480 Potrero

An opportunity to provide needed housing, business, and open space in a densely populated part of the city

Overview

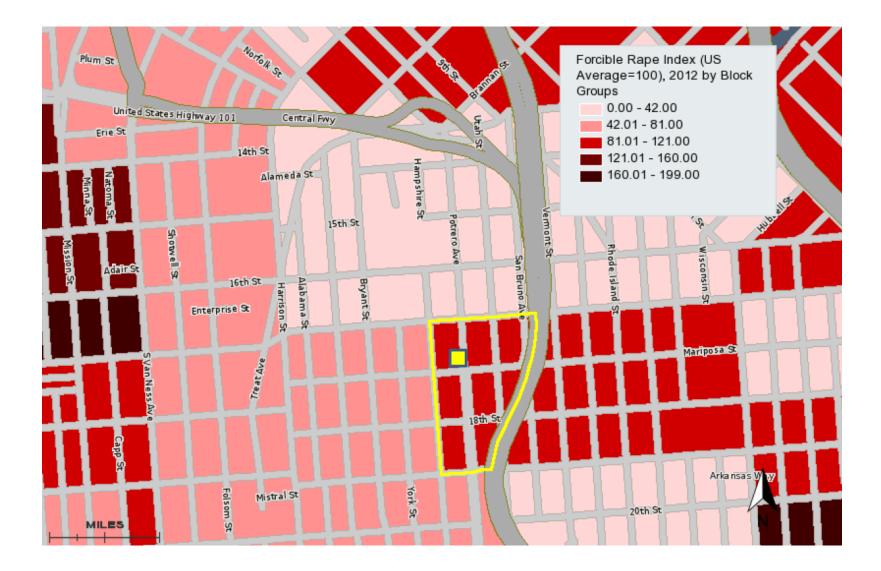
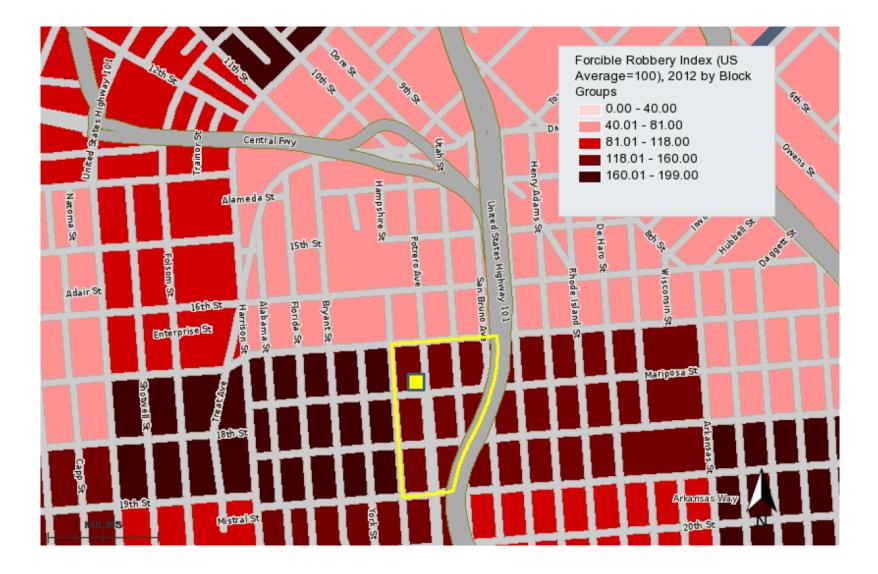
• Verdi Club, Center for Homeless Pregnancy Support (Potrero&18th) and general neighborhood residences have maxed out the existing parking. Adding 84 units and supplying 50 parking spaces is an improvement over an original plan with 38 spaces, but will still add a significant burden to the existing condition.

- Mission Area Plan calls for support of human service providers and cultural resources. Adequate parking is a measure of support.
- Aging adults, those with young children, and injured/ill people may not be able to walk or take the inconsistent and over crowded public transit.
- Safety consequences of decreasing the already saturated parking situation of this location are real. There have been multiple rapes and assaults, occurring with increasing frequency in this immediate neighborhood. All new residents with cars and no parking spaces within the new development will be adding to this significant burden. The current situation (parking 2-4 blocks away) could easily and realistically turn into the need to park 6-10 blocks away with 84 units worth of new residents.

We recommend 4 stories, 56 units for the 50 planned parking spaces.
